Planning reference: 22/04639/FUL
Case Officer: Seán Fallon

Town and Country Planning (Scotland) Act 1997 (as amended)
Re: Temporary use of the Waverley Market roof top for pop-up festival village, including erection of structures and provision of café, bars, food and drink uses, retail kiosks, toilets, seating and ancillary facilities and works at Roof terrace, Waverley Mall, 3 Waverley Bridge, Edinburgh.

Review Consultation

Waverley Mall Walkway Access Route
Indicative Plan

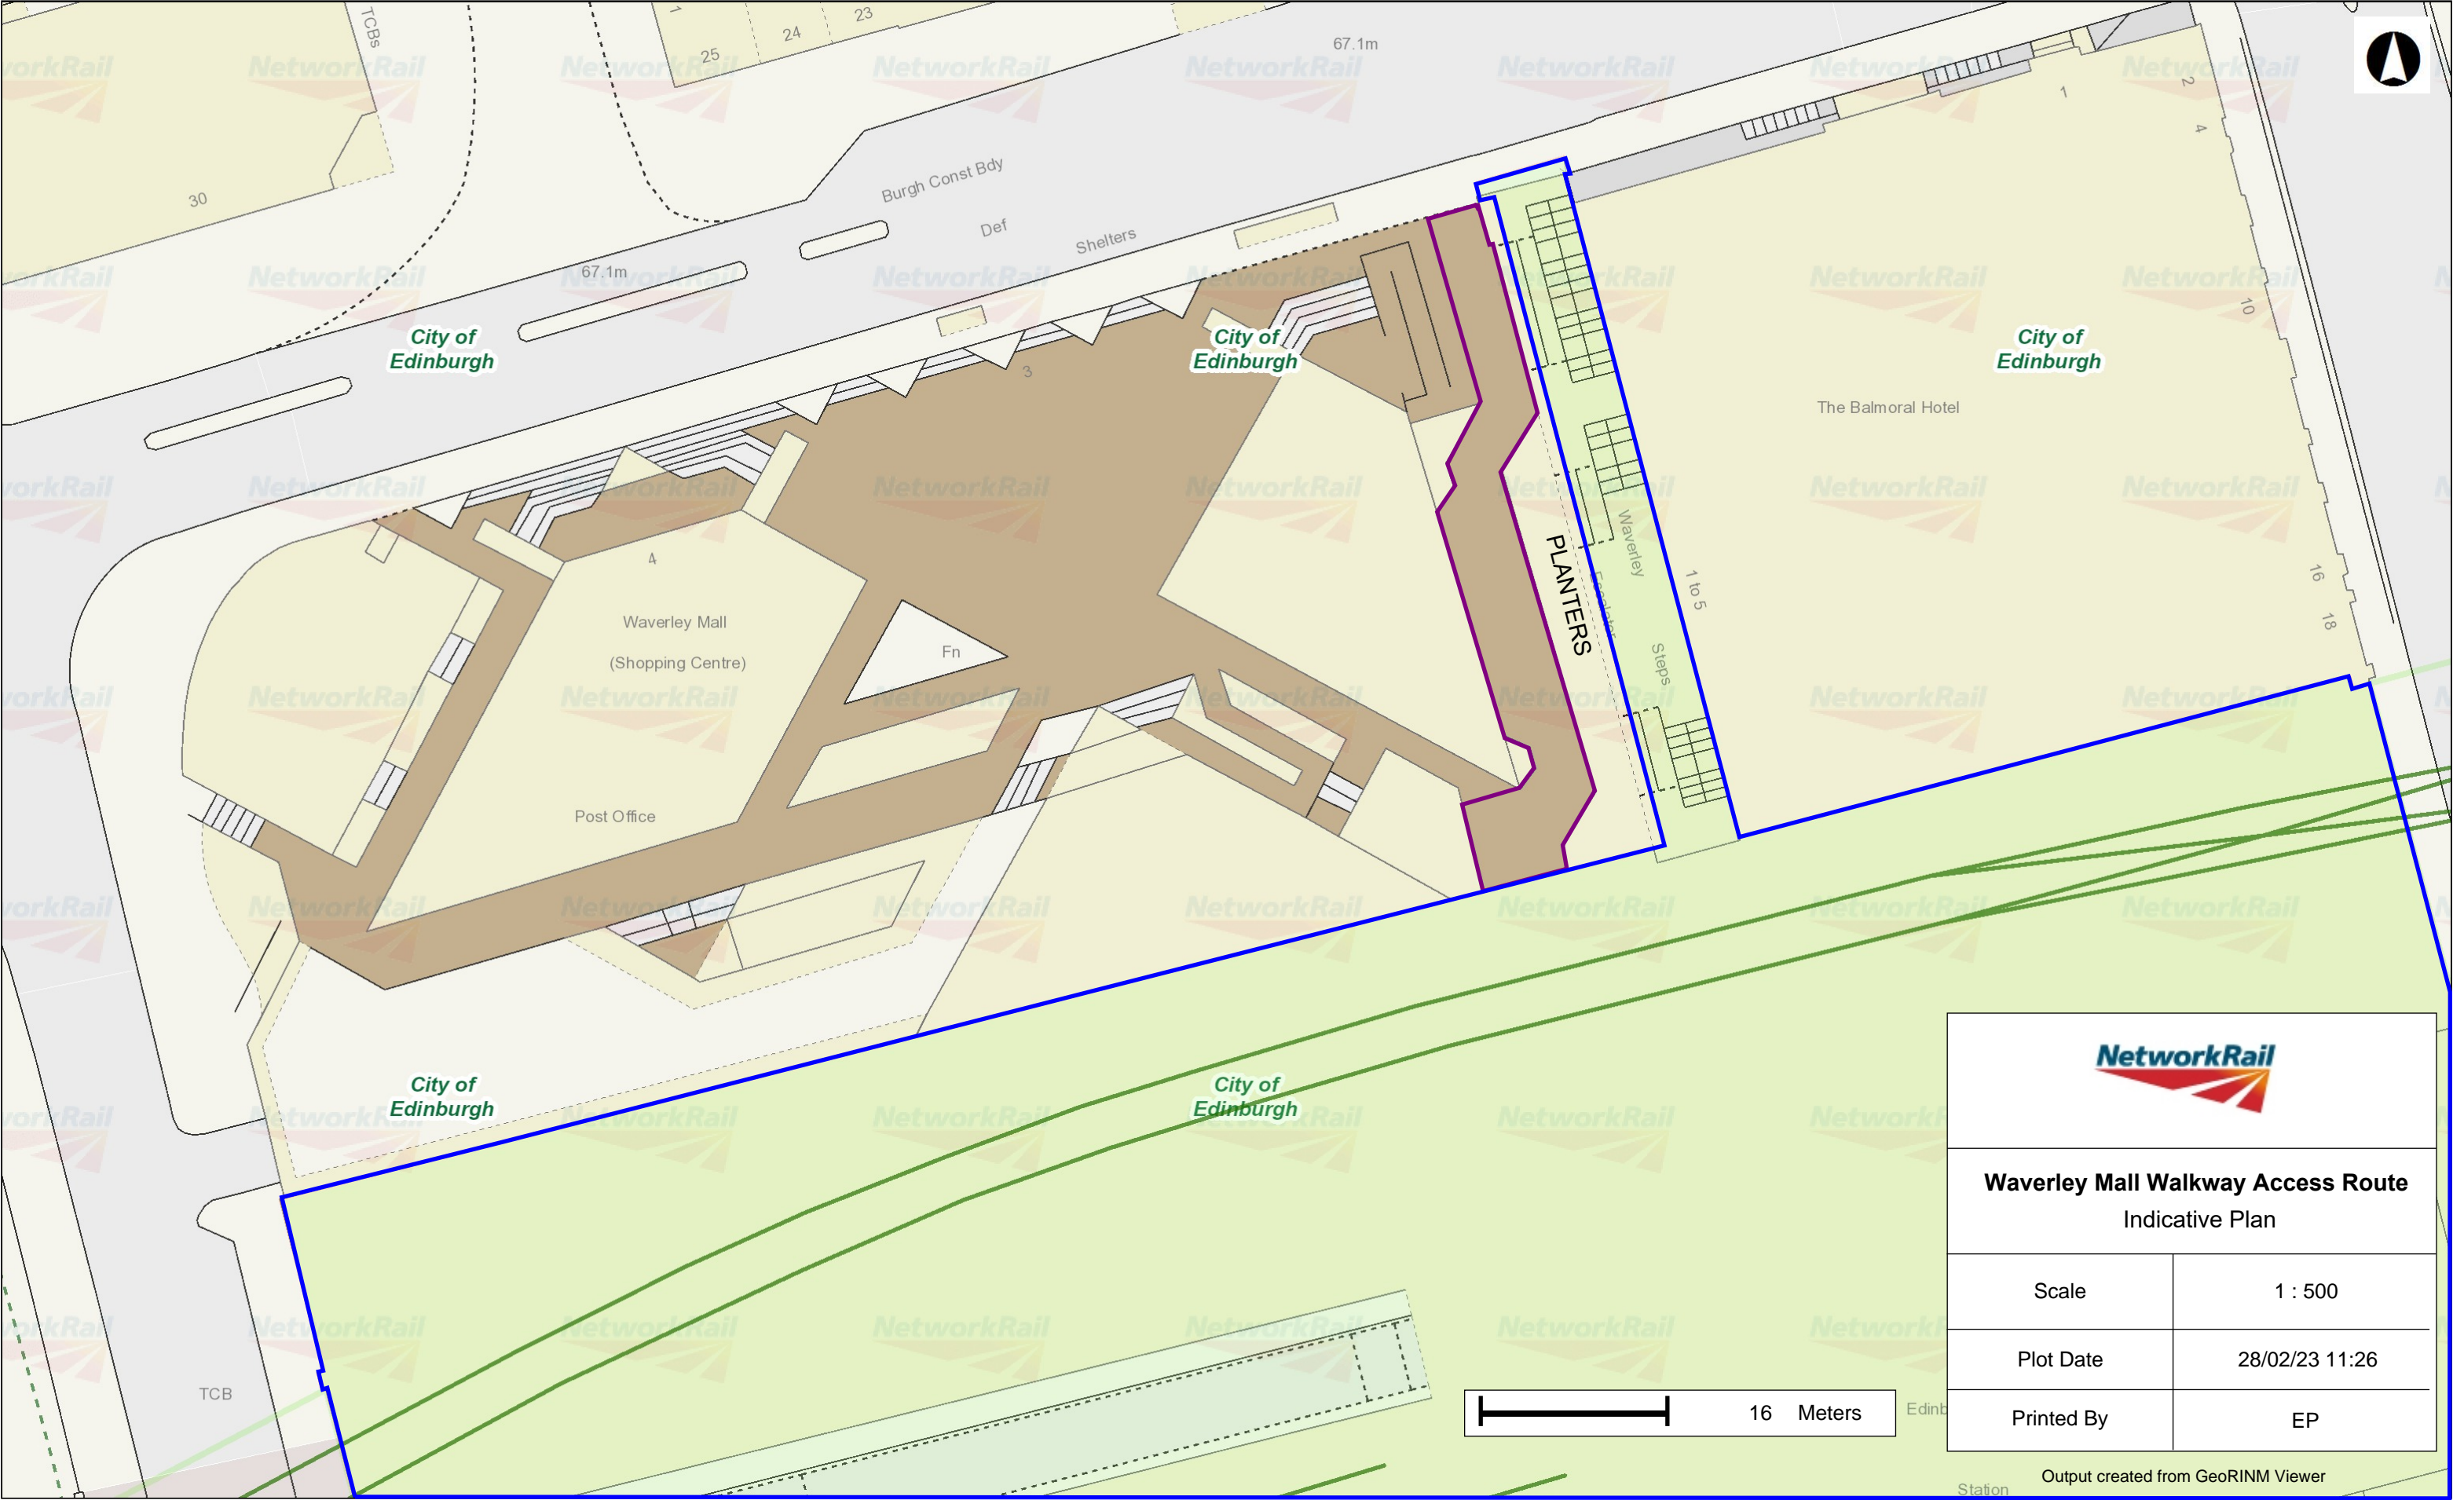
The walkway on the roof of Waverley Mall (shown on drawings 031801-02-03 Waverly [sic] Mall Roof – Site Plan – Existing Temporary Uses and 031801-02-04 Waverly [sic] Mall Roof – Proposed Temporary Uses submitted by the applicant in support of the application, and on the enclosed Waverley Mall Walkway Indicative Plan provided by Network Rail) provides a key accessible route to and from the station between Princes Street and the station.

The current layout of the walkway provides a safe and accessible point of access to the station, allowing sustainable travel for a substantial number of visitors to Edinburgh and those who live and work in the city. The proposed plans show that the planters to the east of this walkway would be removed and the proposed alternative arrangement, comprising kiosks on the west and south sides of the walkway, and tables and chairs lining the east side, is considered by Network Rail highly likely to negatively impact the safe and efficient operation of the station.

The planters to the east side of the walkway currently provide a buffer between the walkway and the station roof. Antisocial behaviour has resulted in damage to the roof and blocking of drainage, which in turn has posed a threat to the safety of users of the station. The removal of the buffer provided by the planters, as well as the siting of tables and chairs adjacent to the edge of the walkway, would increase the likelihood of objects being thrown onto the glass station roof and thus exacerbate the safety risk; as such, Network Rail is opposed to the removal of the planters. Further safety risks, comprising litter/bins and fire hazards have been identified; however, it is considered that these can be dealt with by way of conditions (see below).

Network Rail posits that the proposed development would not be sufficiently accessible as to be consistent with the planning policies detailed above. The operation of the market would likely result in stationary pedestrians on the walkway due to queuing at kiosks, which would limit the clear walking zone and obstruct access to the station. The proposed layout of the walkway would allow for a footpath of 4m width at its narrowest point according to the submitted plans; however, this does not take into consideration the space likely needed for queuing and servicing tables. Moreover, and most importantly, this minimum width is predicated upon the proposed removal of the existing planters, which are crucial to ensuring the protection of the railway infrastructure and the users of the station, as noted above. Given that the planters should not be removed, the remaining space on the walkway (a width of 4.5m at its narrowest point) would not be sufficient to facilitate both the kiosks and associated seating and a clear walking zone sufficient to allow for users of the walkway. As such, the proposals do not result in safe and convenient access and movement and do not have regard to the needs of people with limited mobility or special needs, thus failing to comply with existing and emerging planning policy.
